Comments on Mount Saint Mary's University Chalon Campus Wellness Pavilion Project Final EIR

Travis Longcore, Ph.D. Catherine Rich, J.D., M.A.

July 13, 2021

Figure 5. Map of observations of coastal whiptail in the vicinity of the Project site (circled) as reported on the iNaturalist website.

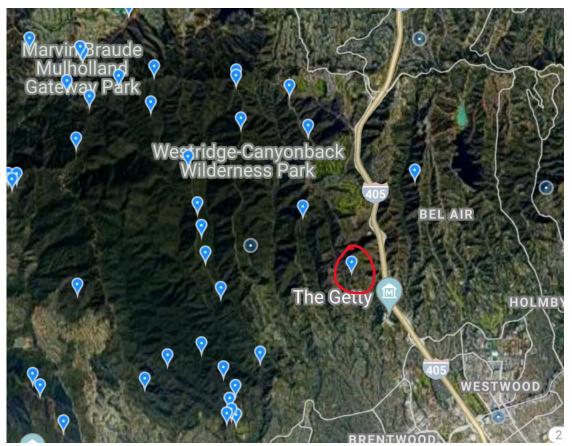
The DEIR and its biological appendices draw the conclusion that coastal whiptail (*Aspidoscelis tigris stejnegeri*) has only a "moderate" probability of being found on site because the nearest occurrence in the California Natural Diversity Database (CNDDB) was 0.7 miles northwest of the project site in 2007. This conclusion represents a misuse of the CNDDB and ignores other available sources of information. CNDDB records are opportunistically reported and do not represent exhaustive surveys. They are meant to aid consultants in deciding what species or natural communities might be in the vicinity as a means to guide surveys for project-level analysis. They do not, and cannot, replace surveys when a species might be present. In this instance, community science records in the form of a geotagged photograph and observation on the iNaturalist platform (https://www.inaturalist.org/observations/7936615) is evidence of the potential presence of coastal whiptail on the MSMU property immediately north of the Project area. Furthermore, iNaturalist contains many observations identified as coastal whiptail within the natural open space contiguous with the Project site. The applicant therefore must undertake appropriate surveys to determine presence, or assume that existing habitat is in fact occupied.

The impact analysis for coastal whiptail is similarly flawed. The FEIR describes the potential loss of 0.9 acres of habitat, but assumes this impact is not significant because individuals would "flee" fuel modification activities and so there would be no direct impacts. Habitat loss is a direct impact, regardless of whether individuals escape with their lives, albeit temporarily. The conclusion in the FEIR is sort of like arguing that it would not be a significant impact to burn a person's house down so long as the person had been able to evacuate without being injured. And unlike people, who can be rehoused, wildlife that are displaced by habitat destruction do not usually survive because the resources in the areas where they end up are already in use by other individuals. It is for this reason that relocation of wildlife into areas already occupied by the species is not considered to be an effective mitigation measure (Bradley et al. 2020).
